Access Compliance Report

Public Rights-of-Way

(Curb Ramps)

Intersection ID: 11712	Main Street: ALLEN_ST	Cross Street: E_20TH_ST	Location:	N
ADA ID: 3F30245D9DCA	Ramp Type: PerpDiag	Initial Pass/Fail: Fail	Overall Compliance: No	Severity Score: 22.5
Codes/Mitigation Info/Possible Solution		Field Measurements/Component Compliance

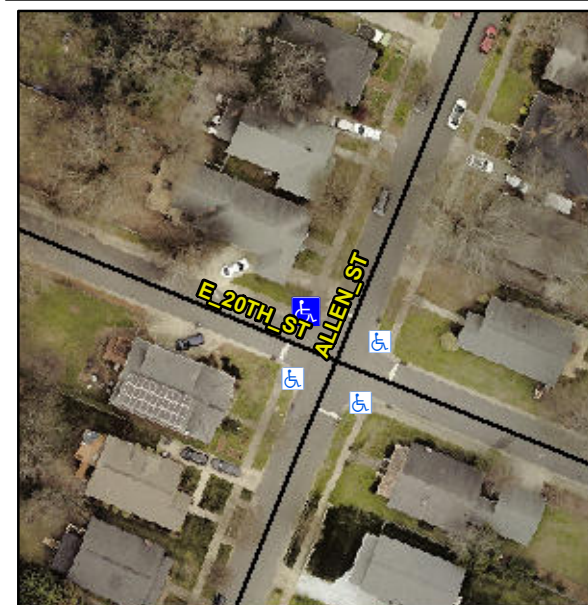
Not Found, R304.5.1, R304.2.2, R304.5.3

Compliance	Description	Data	Compliance	Description	Data
N/A	Ramp Length (in)	68.0	No	Ramp Slope (%)	10.2
No	Ramp Width (in)	40.0	No	Ramp XSlope (%)	3.1
N/A	Flare Type LT	N/A	N/A	Flare Type RT	N/A
N/A	Flare Slope LT (%)	N/A	N/A	Flare Slope RT (%)	N/A
N/A	Flare Traversable LT?	N/A	N/A	Flare Traversable RT?	N/A
N/A	Landing Length (in)	N/A	N/A	DWS Provided?	N/A
N/A	Landing Width (in)	N/A	N/A	DWS Contrast?	N/A
N/A	Landing Slope (%)	N/A	N/A	DWS Length (in)	N/A
N/A	Landing X Slope (%)	N/A	N/A	DWS Full Width?	N/A
N/A	Landing Curb? (Y/N)	N/A	N/A	DWS Offset (in)	N/A
N/A	Shared Landing?	N/A			
N/A	Gutter Ponding?	N/A	N/A	Gutter Slope (%)	N/A
N/A	Gutter Lip Ht (in)	N/A	N/A	Gutter X Slope (%)	N/A
N/A	Painted X Walk1?	No	N/A	Painted X Walk2?	No
	X Walk 1 Direction	To SW		X Walk 2 Direction	To SE
N/A	X Walk 1 Width (in)	N/A	N/A	X Walk 2 Width (in)	N/A
	X Walk 1 Slope (%)	3.2		X Walk 2 Slope (%)	4.4
	X Walk 1 X Slope (%)	5.3		X Walk 2 X Slope (%)	0.2

Remove & Replace Curb Ramp With Two New Directional Ramps or Equivalent.
